**CITY OF BATON ROUGE
PARISH OF EAST BATON ROUGE
DEPARTMENT OF ENVIRONMENTAL SERVICES**

ADDENDUM NO. 2R

SUBJECT: **PS 299 REGIONAL PUMP STATION**

CITY-PARISH PROJECT NO. 20-PS-IF-0109R

CIVIL
SEWER PLAN AND PROFILE -- 1

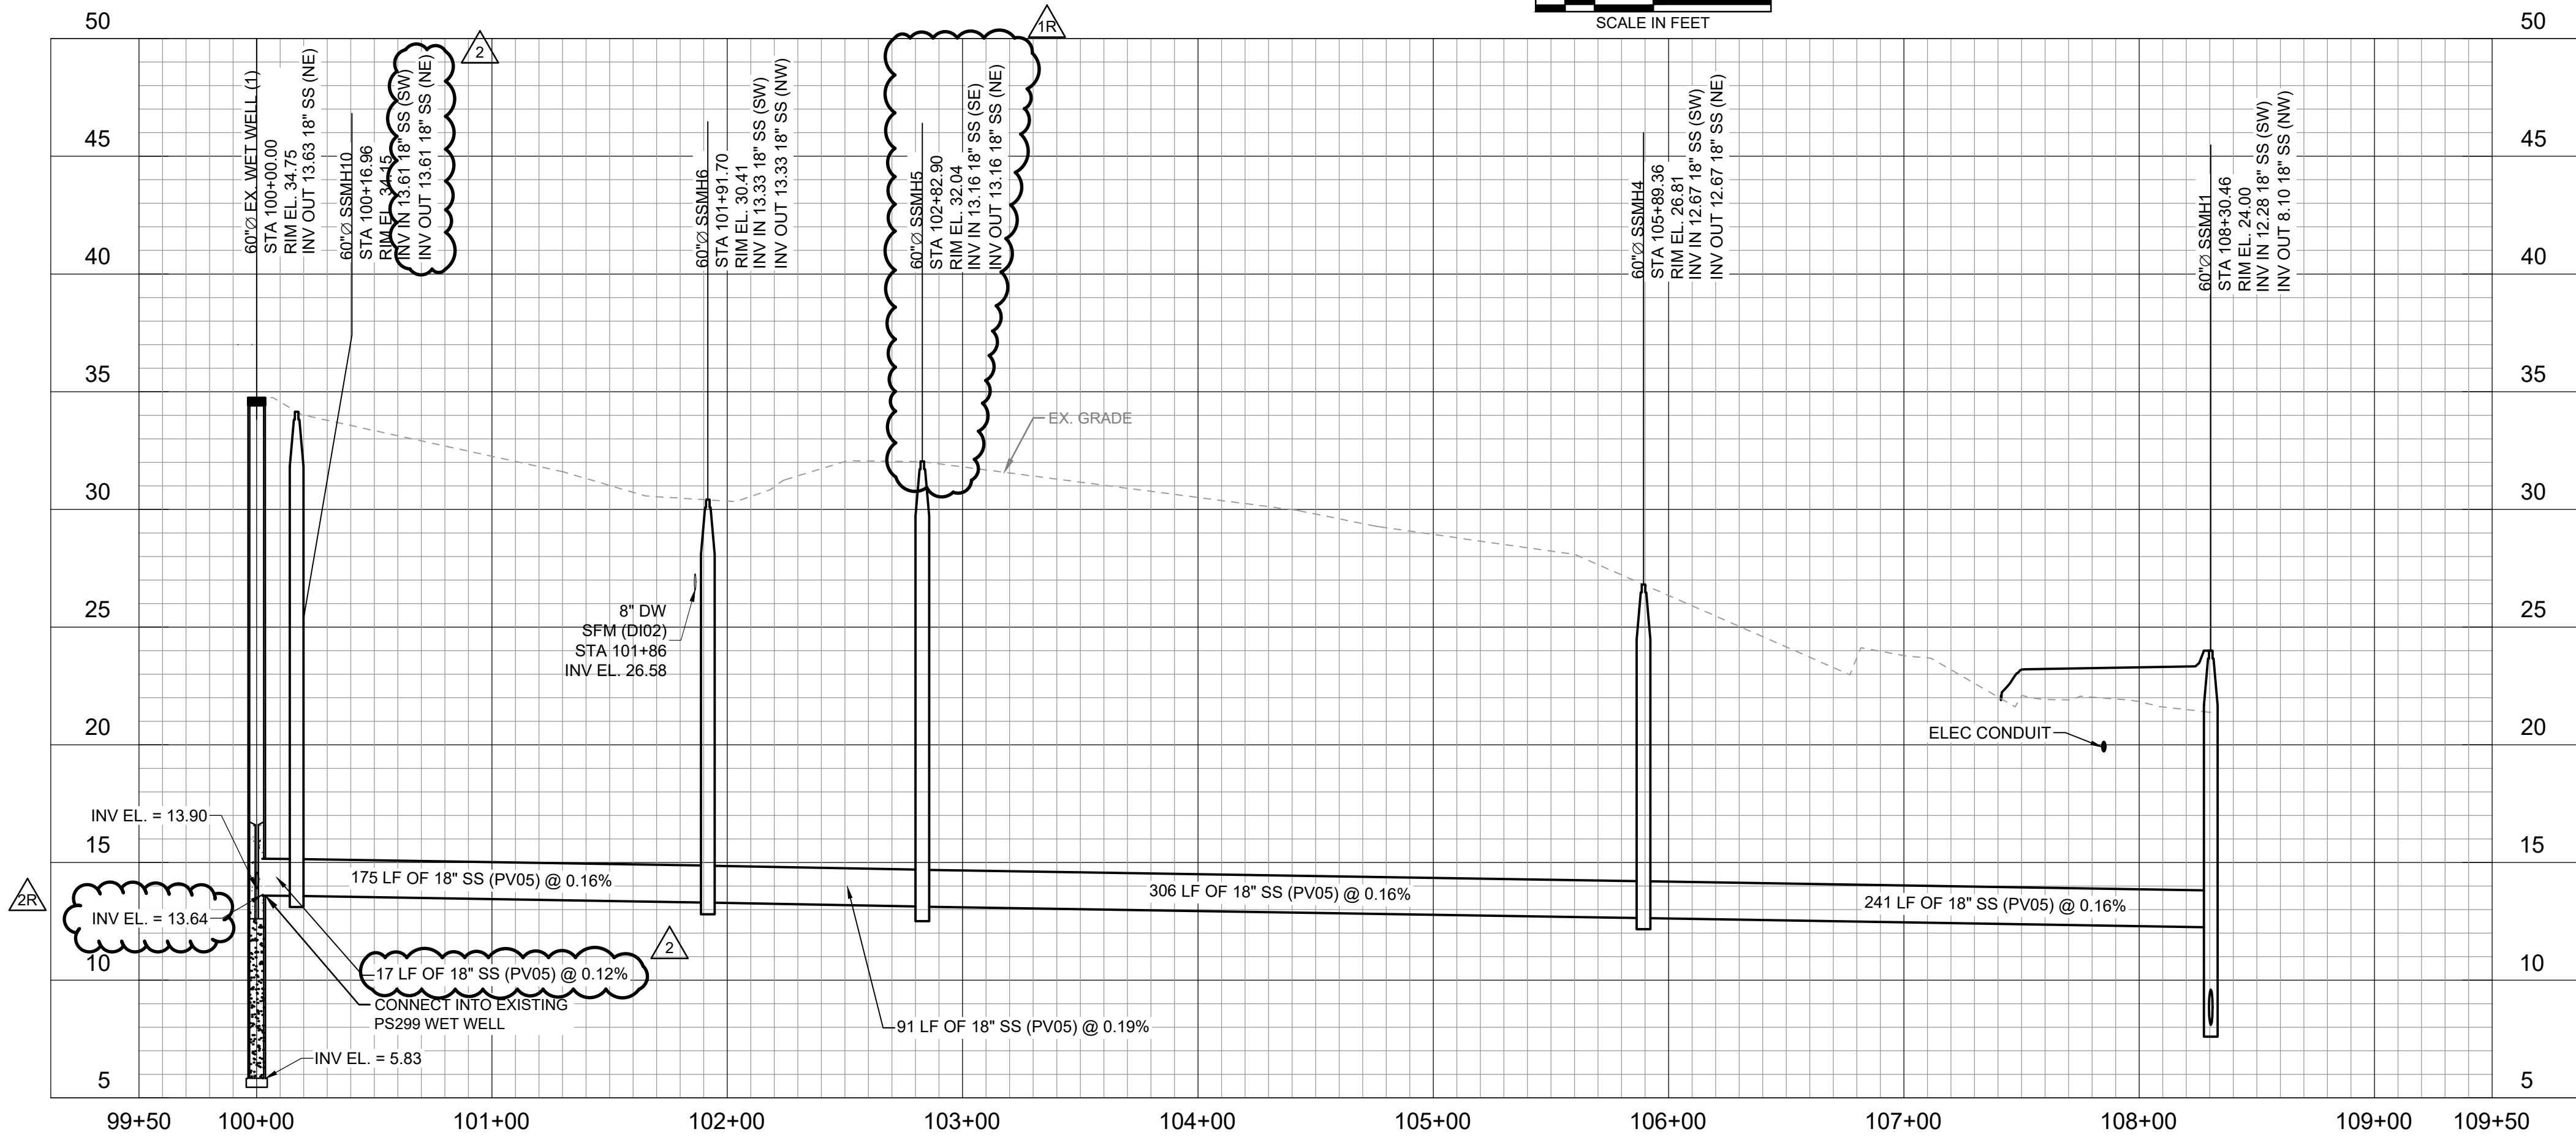
4. Please confirm we can still deviate from the 1' thickness as this thickness is only for 120" and larger manholes.

The Contractor may deviate from the specified thickness, but is required to provide signed structural calculations, included buoyancy calculations as required by the note.
